**STAFF REPORT: OCTOBER 12, 2022 MEETING**

**APPLICATION NUMBER: 22-8054**

**ADDRESS: 19355 PARKSIDE**

**SCOPE: INSTALL NEW WINDOW (WORK COMPLETED WITHOUT APPROVAL)**

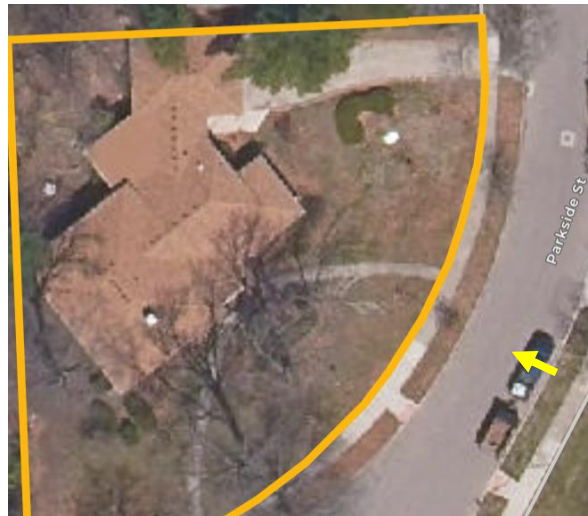
The application before the Commission is to approve the replacement window as installed (below right), which includes vertical bars in the upper glass areas.

- The new window order with visual mockup for Line 15, showing vertical bars in the upper glass (submitted by the applicant as part of this application) *was not* submitted to HDC staff for review. Nor, was this document part of the permit application BLD2021-03378 which staff approved electronically on July 10, 2021.

- Due to the inherent strength of steel, muntins and mullions in a steel window are very thin and create a delicate appearance to the window opening due to the expanse of glass allowed, and sometimes creative muntin patterns and multiple window operations. Replacement windows have thick outer frames and generally cannot duplicate multiple sash operations in one opening. It is staff's opinion that no replacement sash, outside of a new steel sash, can match or mimic a steel window.

- Staff believes that even if the replacement window matched the horizontal and lower vertical muntin bars (with clear glass at the top) the sash doesn't replicate the design integrity of the original window. Therefore, staff believes the presence of the vertical bars in the upper glass does not further alter the appearance of the window opening.

It is staff's opinion the alteration of the muntin pattern of the installed window does not impact the features and spaces that characterize the property. Therefore, staff recommends the Commission issue a Certificate of Appropriateness for the work because it meets the Secretary of the Interior Standards for Rehabilitation and the Elements of Design for the district
